**Newark Riverfront Pedestrian and Bicycle Access CD Study**  
**Public Information Center (PIC)**  
**April 11, 2024 | 6:00 – 7:30 PM**  
**MEETING SUMMARY**

- Existing Condition with red lines denoting missing crosswalks:

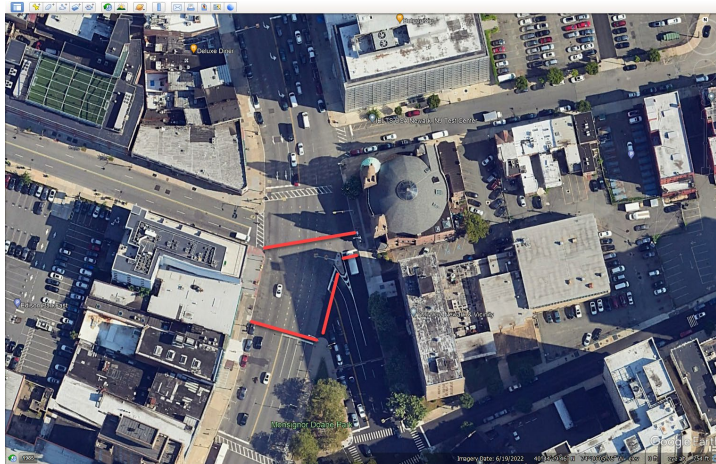
- A participant asked if there was a better way to connect from Military Park to Harriet Tubman Square for bicyclists and pedestrians. There are a number of missing crosswalks at the intersection of Broad St. and Park PL. / Center St.

- T. DiBiase responded that after the project is completed the preferred path for bicyclists would be to utilize bicycle facilities on Central Avenue to University Place. Pedestrian mobility at the intersection is a priority for improvement to be examined as part of the project. The project limits on Broad Street, from Washington Place to Rector Street will limit the extent any proposed bicycle lane on Broad Street. However, the Study may propose cursory bicycle recommendations for Broad Street for further inquiry as part of separate future Studies.
